# Concurrency issues in the PSE state diagram (D3.1) v101

Figure 145–15—Primary Alternative dual-signature semi-independent PSE state diagram

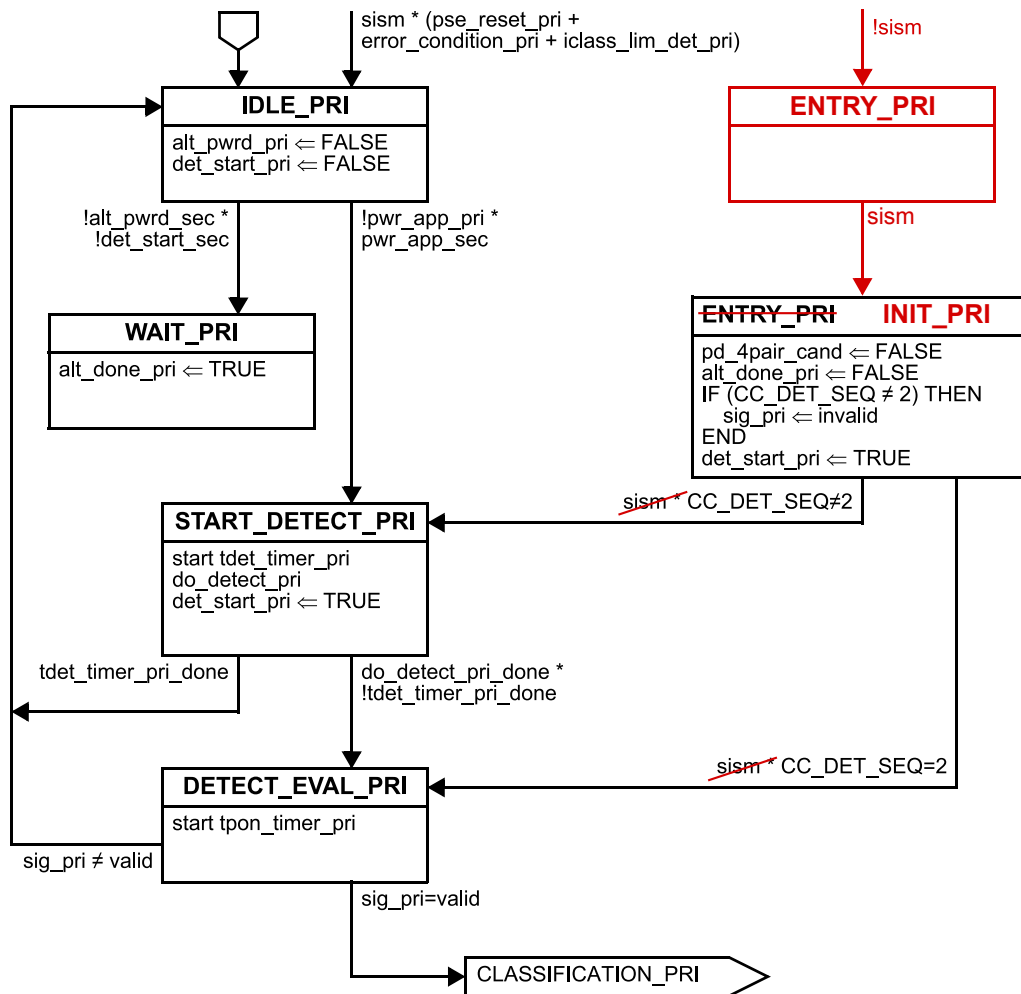
There is an issue in the PSE state diagram where when `sism=FALSE`, both the toplevel state diagram and the Primary/Secondary state diagrams write in variables `pd_4pair_cand`, `sig_pri`, and `sig_sec`. This happens because of the assignment statements in the `IDLE_PRI` and `IDLE_SEC` states. In this baseline these are disabled by introducing a new holding state for the Primary and Secondary SISM state diagrams.

Change Figures in 145.2.5.7 as follows:
